# Central Falls High School

## 100% Construction Documents

Ai3 Project #2202.02

### **Addendum #3**

DRAWN BY: CHR / BFC / MCT / MS  
REVIEWED BY: CHR / KK  
SCALE: AS INDICATED DRAWING NUMBER:  
JOB NO.: 2202.02  
DATE: OCTOBER 13, 2023 **A9.25A**

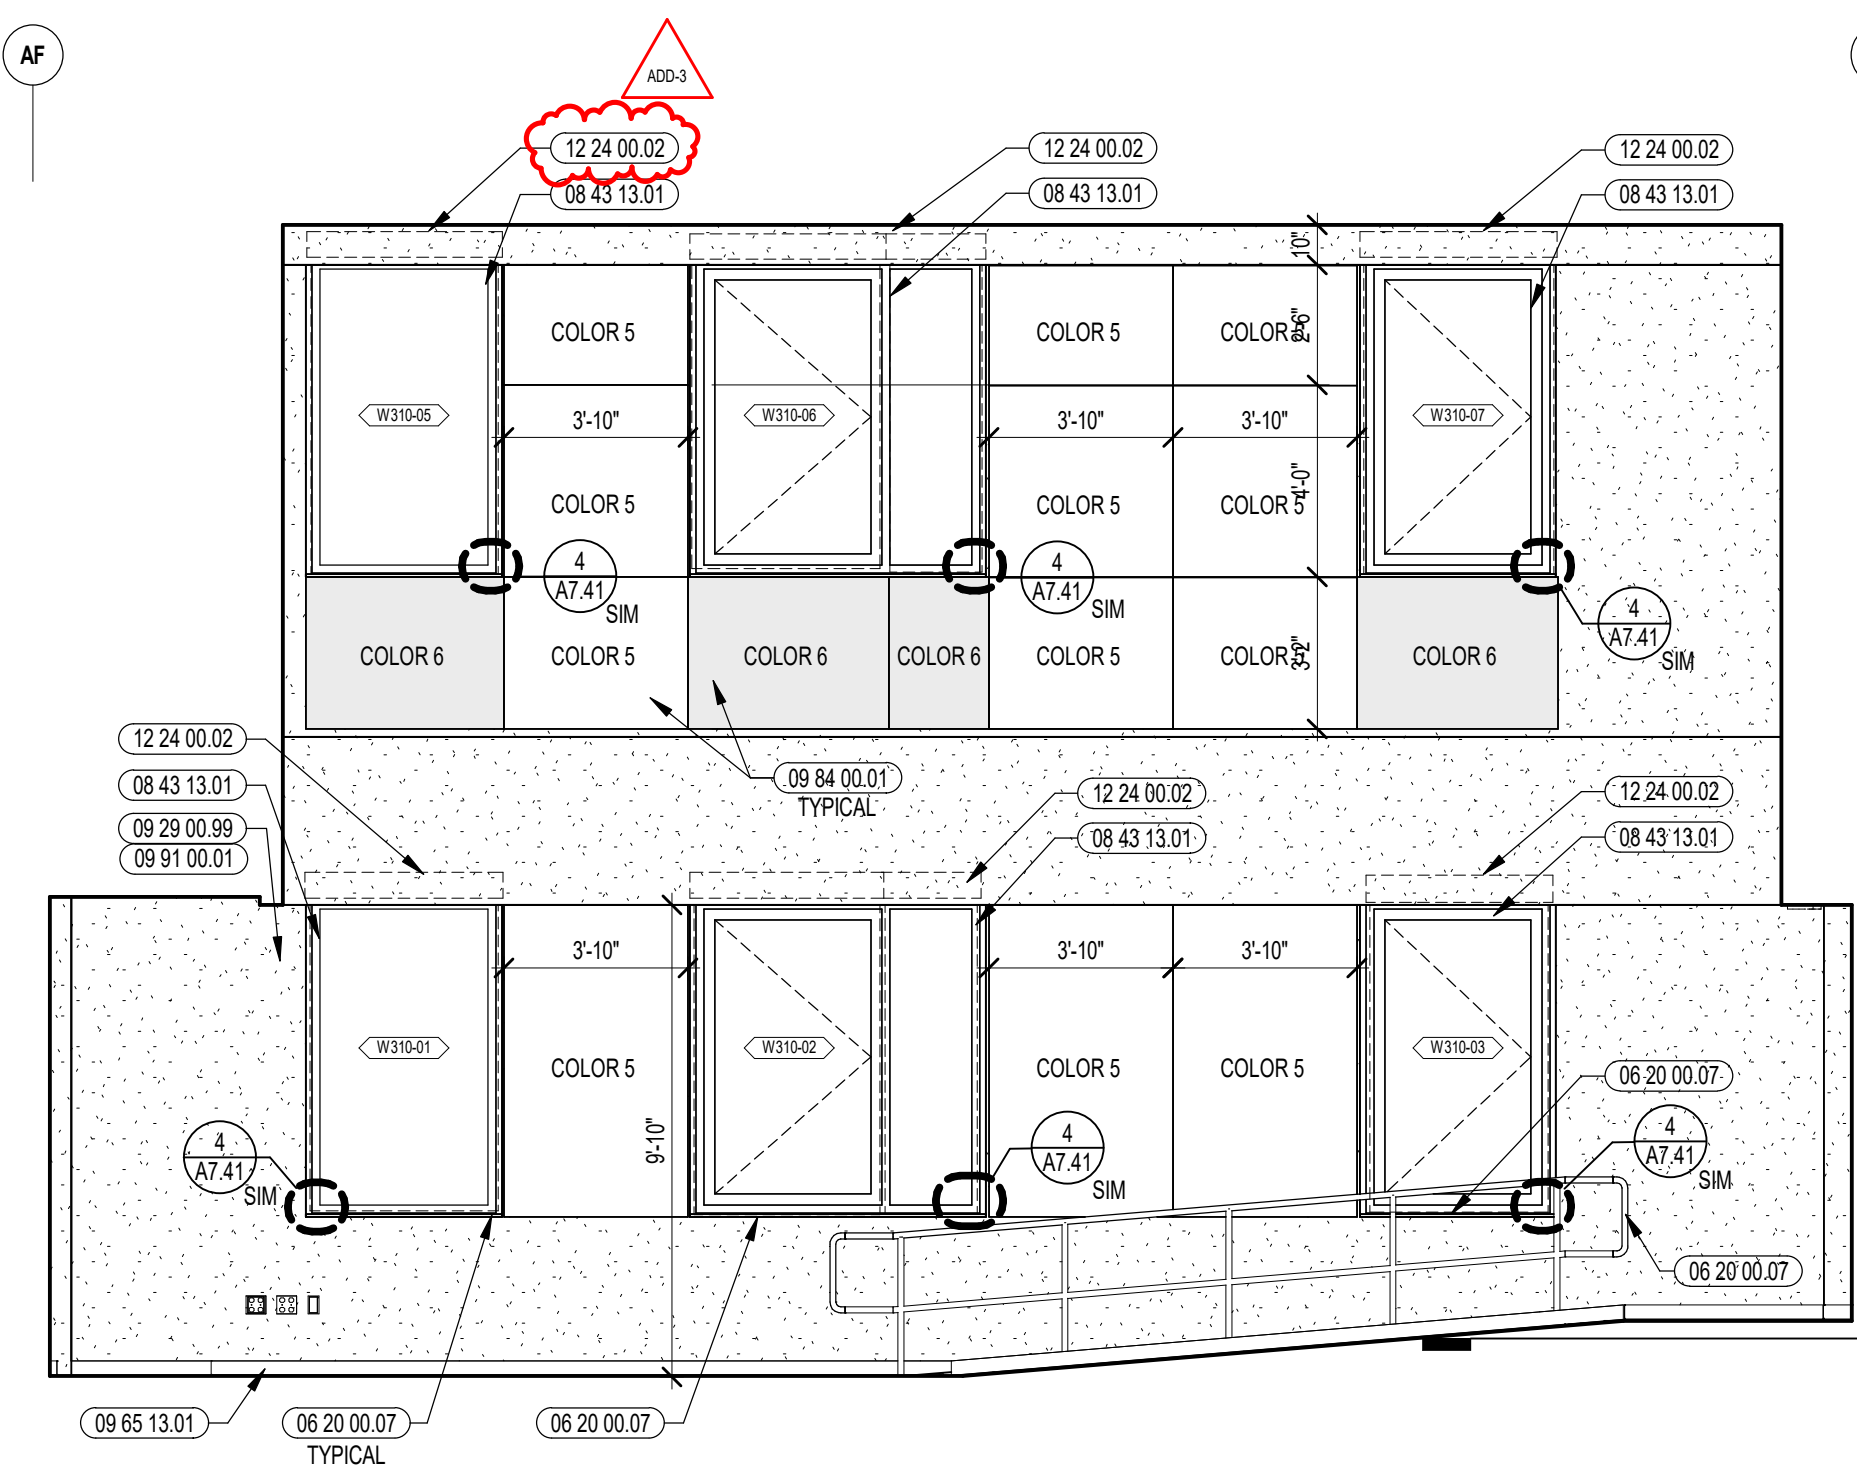
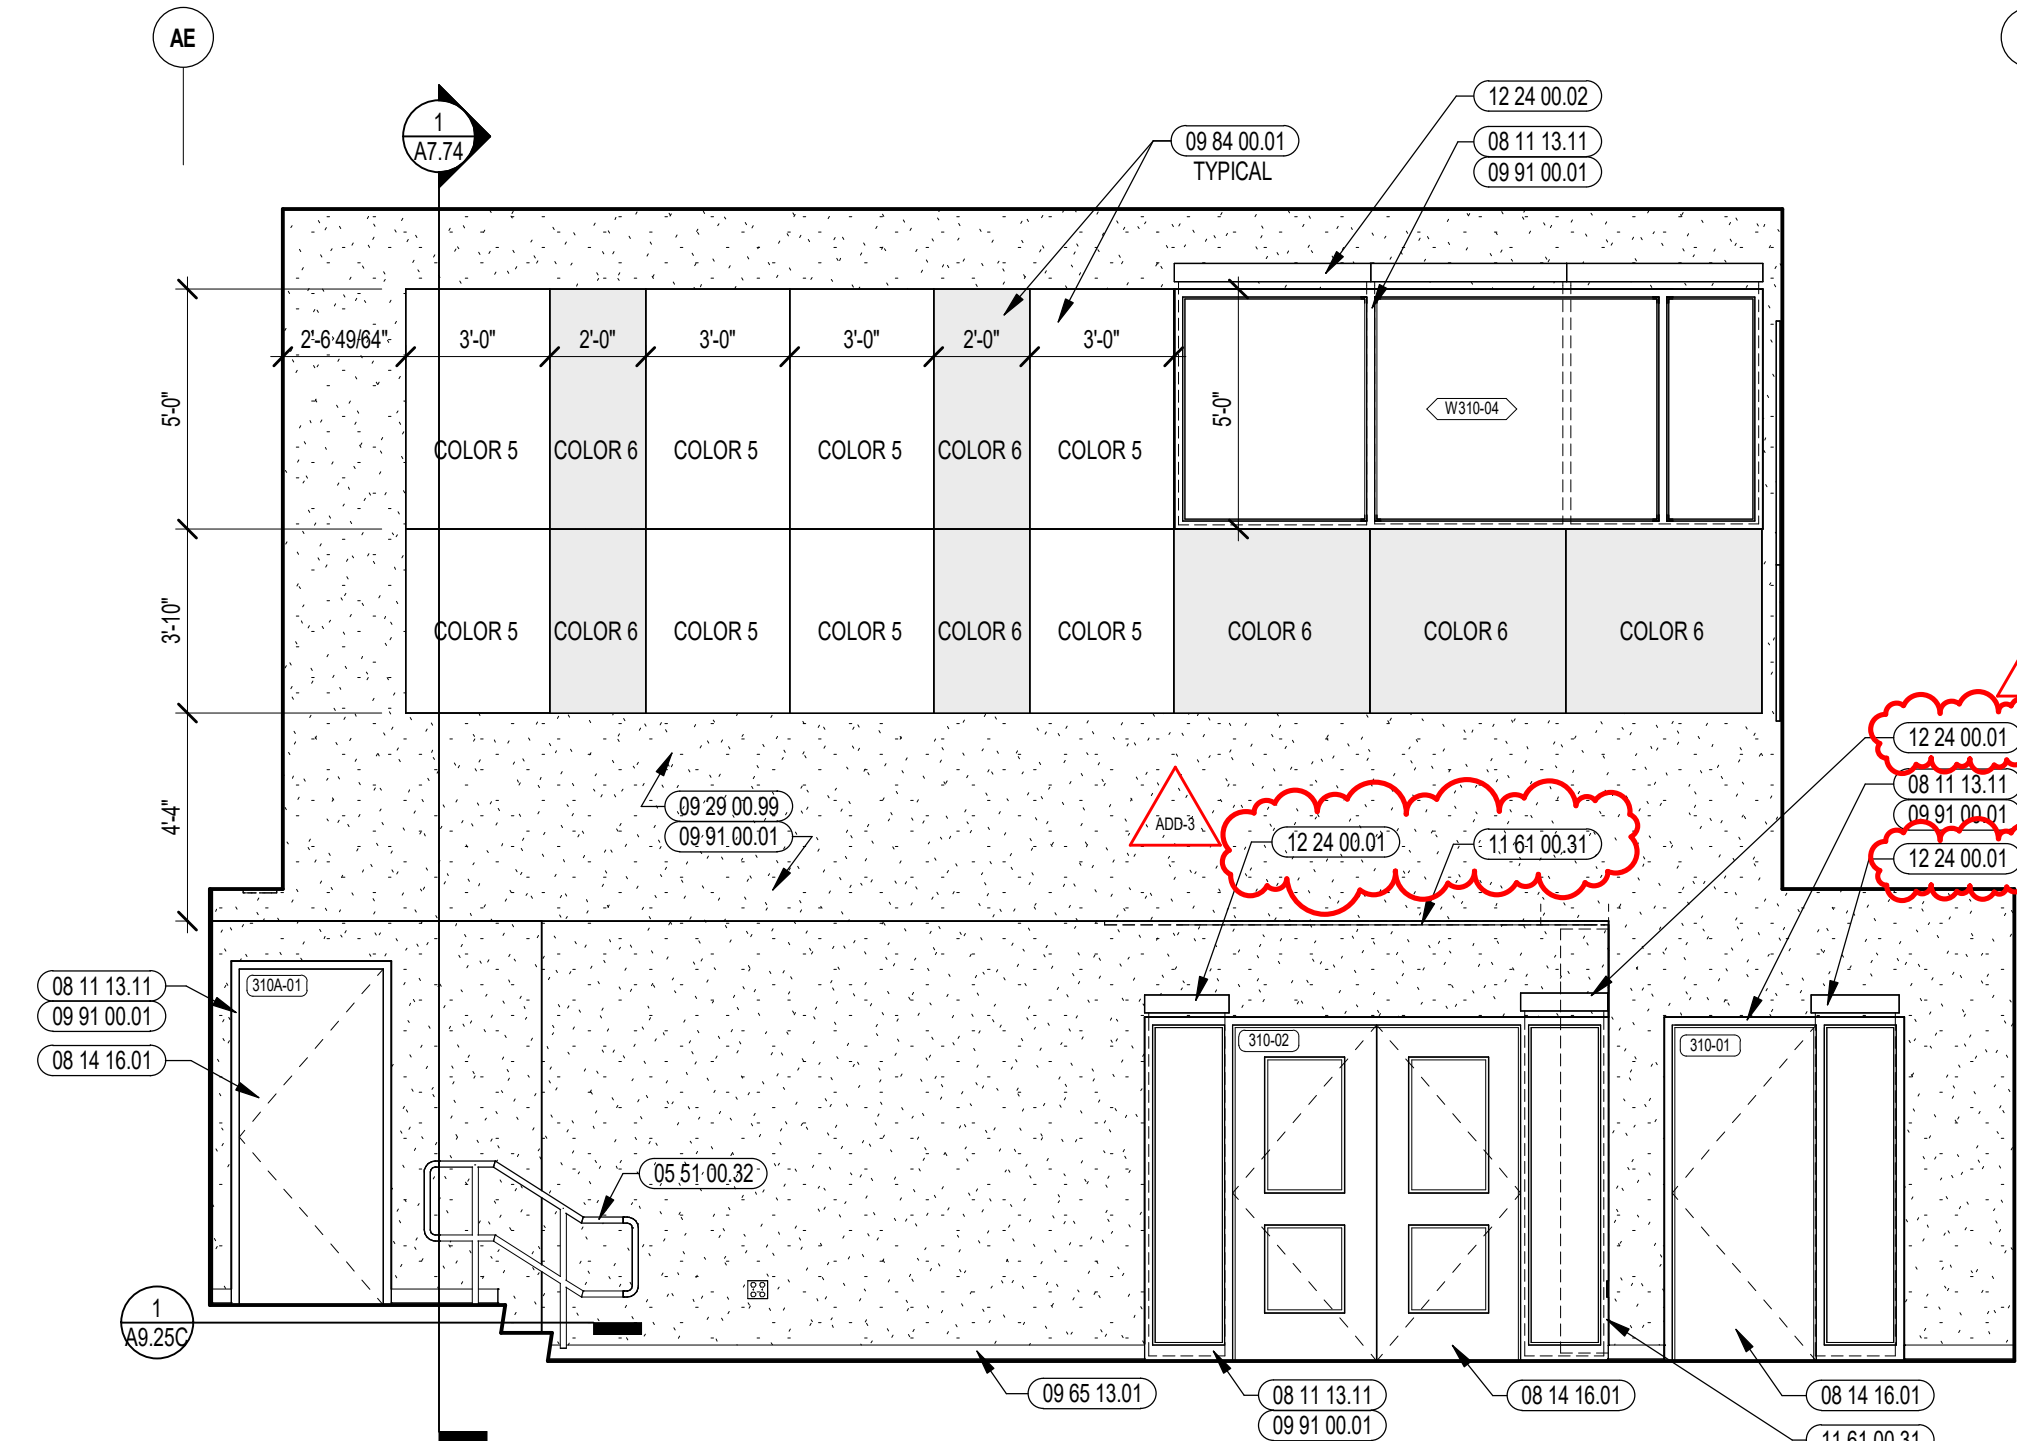
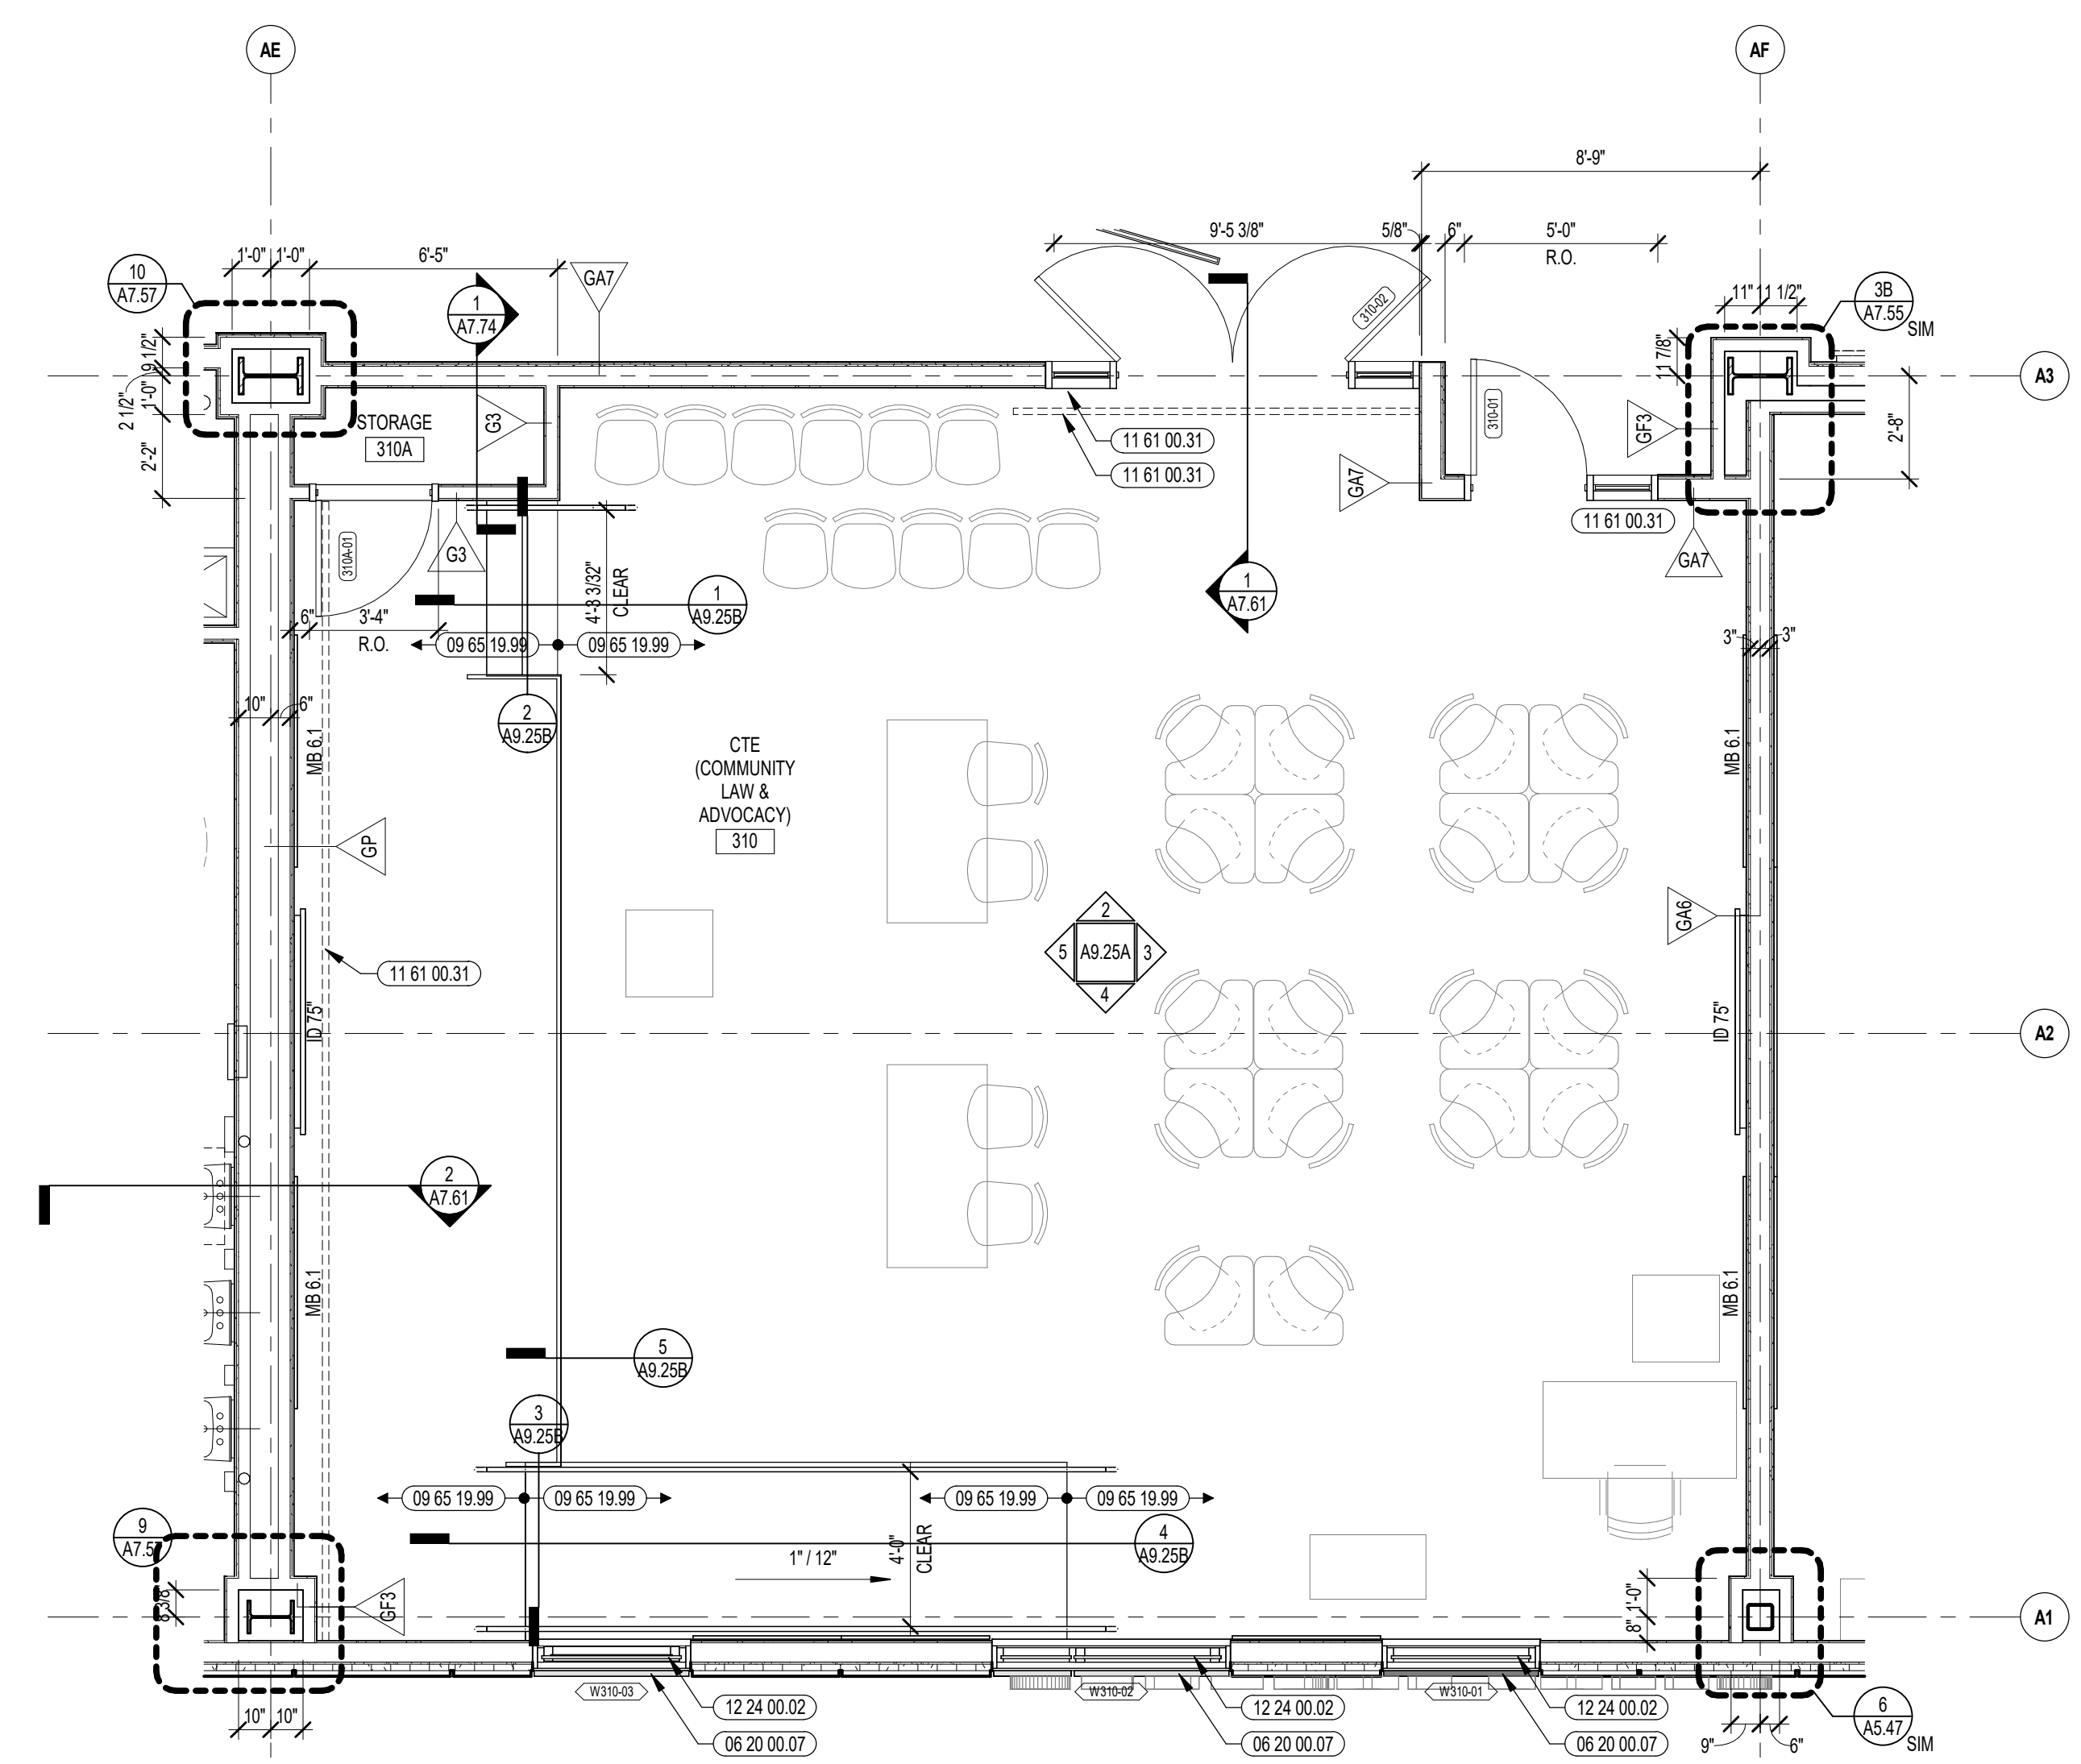
**ADD 3-002** **Bidder Question:** There doesn't seem to be drawings with Window Shade (Section 12 24 00) locations or any notes of the shades on the finished plans. The specs under part 2.1, they state there are roller shades manual, dual roller shades manual, blackout shades manual, and blackout shades motorized with locations for the blackout shades manual and blackout shade motorized. Where are these located? **Response:** Refer to opening details, interior wall sections, enlarged floor plans and elevations for keynoted shade

locations. See additional clarifications on A7.73, A9.25A, A10.20C and A10.41 in Addendum #3.
